# SERVICE PROCEDURE

21503  
MAY 2021

**SUBJECT: NONCOMPLIANCE RECALL**  
**SC-3 Check Valve on certain International® LT®, HV™, MV™, and RH™ Series trucks built 28 July 2020 thru 02 October 2020 with Bendix® air brake system**

**Figure 1. Valve Locations**

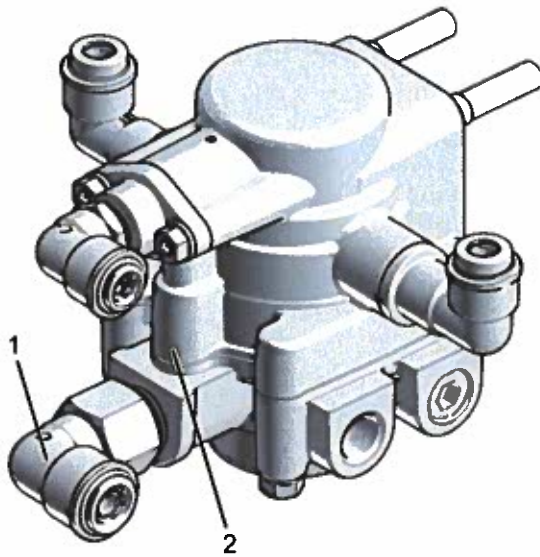
6. Locate SC-3 check valve (Figure 1, Item 1) installed on SR-7 valve (Figure 1, Item 2) and positioned over rear axle of vehicle.
7. Using quick-connect fitting, disconnect air line from check valve.

8. Note orientation of check valve and then remove and discard.

**NOTE:** Orient check valve in tightening direction only. **DO NOT BACK OFF (LOOSEN)** to correctly orient check valve. If correct orientation cannot be achieved when new check valve is tightened 1 ½ to 2 turns from hand tight, continue to turn check valve up to one-half turn more to attain correct orientation.

9. Install new check valve to match orientation of valve noted in Step 8.
